Access Compliance Report

Public Rights-of-Way

(Pedestrian Signals)

Intersection ID: N/A	Main Street:	Cross Street: N/A	Location: N/A
ADA ID: 86DEC3EE920C	Signal Type: One Push Button-Non APS	Overall Compliance: No	Severity Score: BTN 1: N/A BTN 2: N/A No BTN: N/A
Codes/Mitigation Info/Possible Solution		Field Measurements/Component Compliance

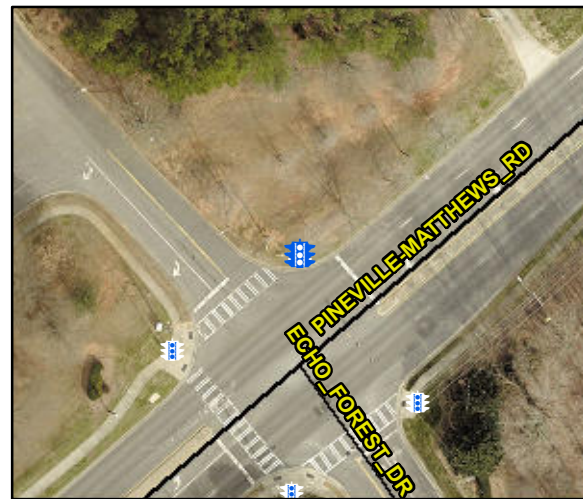
Compliance	Description	Data	Compliance	Description	Data
	Button Count	Button1	N/A	Distant to Additional Button (in)	N/A
	Additional Button Present?	No		Additional Button ID	N/A
N/A	Signal Buttons Required?	N/A	N/A	Additional Ped Posts Required	N/A
	How Many Ped Street Xings?	1		Located In An Island/Median?	No
N/A	B 1 Sign Present?	Yes	N/A	B 2 Sign Present?	N/A
Yes	B 1 Sign Purpose?	Yes	N/A	B 2 Sign Purpose?	N/A
Yes	B 1 Sign Lettering & Contrast?	Yes	N/A	B 2 Sign Lettering & Contrast?	N/A
Yes	B 1 Parallel To XWalk?	Yes	N/A	B 2 Parallel To XWalk?	N/A
No	B 1 PAR to Button?	No	N/A	B 2 PAR to Button?	N/A
No	B 1 PAR to XWalk?	No	N/A	B 2 PAR to XWalk?	N/A
No	B 1 Clear Floor Space?	No	N/A	B 2 Clear Floor Space?	N/A
No	B 1 FWD Approach?	No	N/A	B 2 FWD Approach?	N/A
N/A	B 1 FWD Approach Constrained?	N/A	N/A	B 2 FWD Approach Constrained?	N/A
N/A	B 1 FWD Approach Reach (in)	N/A	N/A	B 2 FWD Approach Reach (in)	N/A
N/A	B 1 FWD Approach Width (in)	N/A	N/A	B 2 FWD Approach Width (in)	N/A

N/A	B 1 FWD Approach Obstruction?	N/A	N/A	B 2 FWD Approach Obstruction?	N/A
N/A	B 1 FWD Approach Obstruction Dist (in)	N/A	N/A	B 2 FWD Approach ObstructionDist (in)	N/A
No	B 1 PARA Approach?	No	N/A	B 2 PARA Approach?	N/A
N/A	B 1 PARA Approach Constrained?	N/A	N/A	B 2 PARA Approach Constrained?	N/A
N/A	B 1 PARA Approach Reach (in)	N/A	N/A	B 2 PARA Approach Reach (in)	N/A
N/A	B 1 PARA Approach Width (in)	N/A	N/A	B 2 PARA Approach Width (in)	N/A
N/A	B 1 PARA Approach Obstruction?	N/A	N/A	B 2 PARA Approach Obstruction?	N/A
N/A	B 1 PARA Approach Obstruction Dist (in)	N/A	N/A	B 2 PARA Approach ObstructionDist (in)	N/A
N/A	B 1 Clear Floor Space Slope (%)	N/A	N/A	B 2 Clear Floor Space Slope (%)	N/A
N/A	B 1 Clear Floor Space XSlope (%)	N/A	N/A	B 2 Clear Floor Space XSlope (%)	N/A
N/A	B 1 PAR Slope (%)	N/A	N/A	B 2 PAR Slope (%)	N/A
Yes	B 1 Height (in)	36.0	N/A	B 2 Height (in)	N/A
Yes	B 1 Pressure (#)	3.0	N/A	B 2 Pressure (#)	N/A

Yes	B 1 Clear Xing Direction?	ClearlyMarked	N/A	B 2 Clear Xing Direction?	N/A
	B 1 Crossing Direction	To SW		B 2 Crossing Direction	N/A
Yes	B 1 DistanceTo XWalk (in)	0.0	N/A	B 2 DistanceTo XWalk (in)	N/A
No	B 1 DistanceTo Curb (in)	83.0	N/A	B 2 DistanceTo Curb (in)	N/A
Yes	B 1 Diameter (in)	2.0	N/A	B 2 Diameter (in)	N/A

Is Button 1 APS or Non-APS?	NonAPS	Is Button 2 APS or Non-APS?	N/A
N/A B 1 VibroTact Arrow?	N/A	N/A B 2 VibroTact Arrow?	N/A
N/A B 1 VibroTact Parallel to Xing?	N/A	N/A B 2 VibroTact Parallel to Xing?	N/A
N/A B 1 VibroTact Contrast	N/A	N/A B 2 VibroTact Contrast	N/A
N/A B 1 Pilot Light?	N/A	N/A B 2 Pilot Light?	N/A
N/A B 1 Pilot Light Illumination?	N/A	N/A B 2 Pilot Light Illumination?	N/A
N/A B 1 Verbal Walk Cycle?	N/A	N/A B 2 Verbal Walk Cycle?	N/A
N/A B 1 Verbal Message Audible?	N/A	N/A B 2 Verbal Message Audible?	N/A
N/A B 1 Locator Tone?	N/A	N/A B 2 Locator Tone?	N/A
N/A B 1 Percussive Walk Cycle?	N/A	N/A B 2 Percussive Walk Cycle?	N/A
N/A B 1 Extended Press Feature?	N/A	N/A B 2 Extended Press Feature?	N/A
N/A B 1 Tone Audible Range?	N/A	N/A B 2 Tone Audible Range?	N/A

Possible Solutions: Replace Signal Push Button With APS Button on New Post. Remove & Relocate Sign.
